**FINAL
ENVIRONMENTAL IMPACT STATEMENT**

**Liquid Metal
Fast Breeder Reactor
Program**

COVER SHEET
DOE/EIS-0085-FS
FINAL ENVIRONMENTAL IMPACT STATEMENT
(Supplement to ERDA-1535, December 1975)
LIQUID METAL FAST BREEDER REACTOR PROGRAM
U.S. DEPARTMENT OF ENERGY

Figure 1

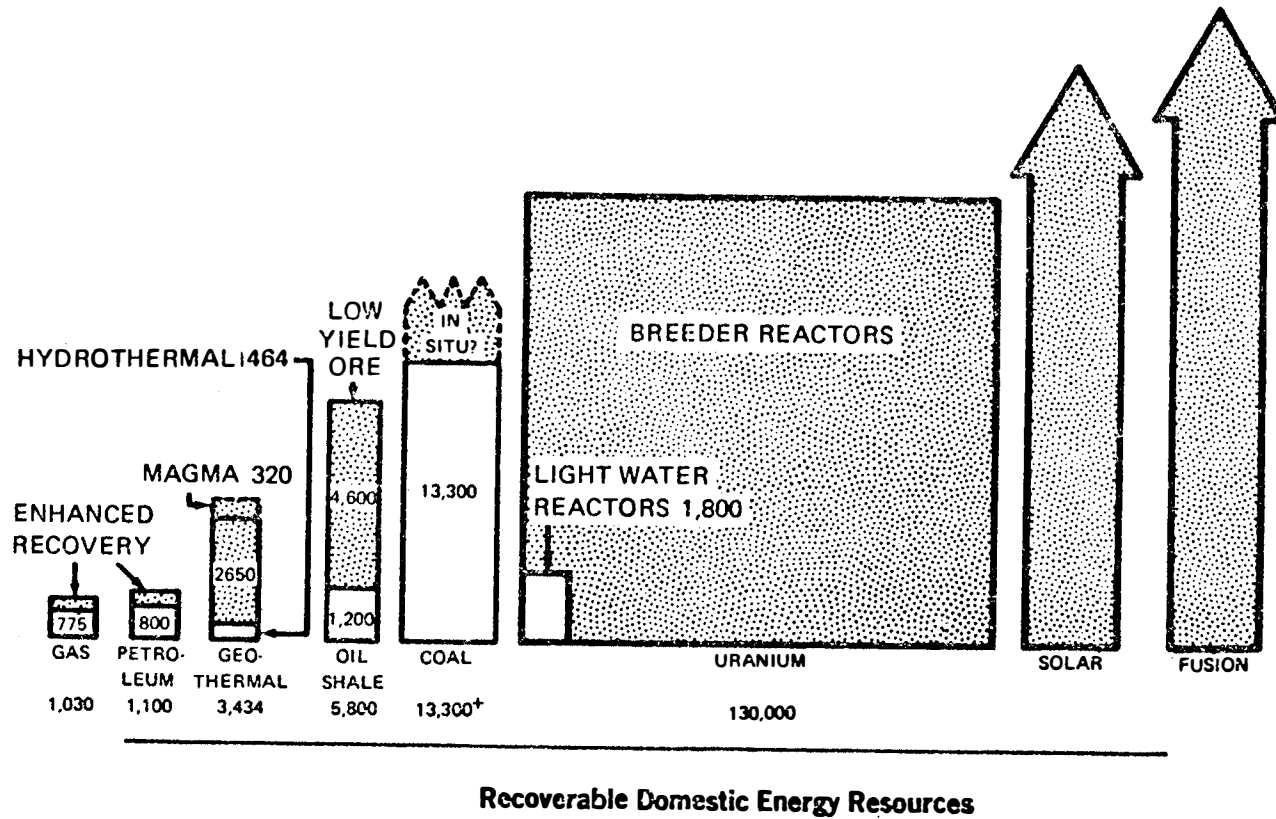
alternatives). An example of the poor quality of the analysis of alternatives is Figure 1 (DEIS, p. 31) which provides a dated (1976) comparison of energy available from renewable energy resources. Such information does not reflect significant recent advances in renewable energy technologies, particularly in photovoltaics, wind, small hydroelectric, etc..

"An example of the poor quality of the analysis of alternatives is Figure 1 (DEIS, p. 31) which provides a dated (1976) comparison of energy available from renewable energy resources. Such information does not
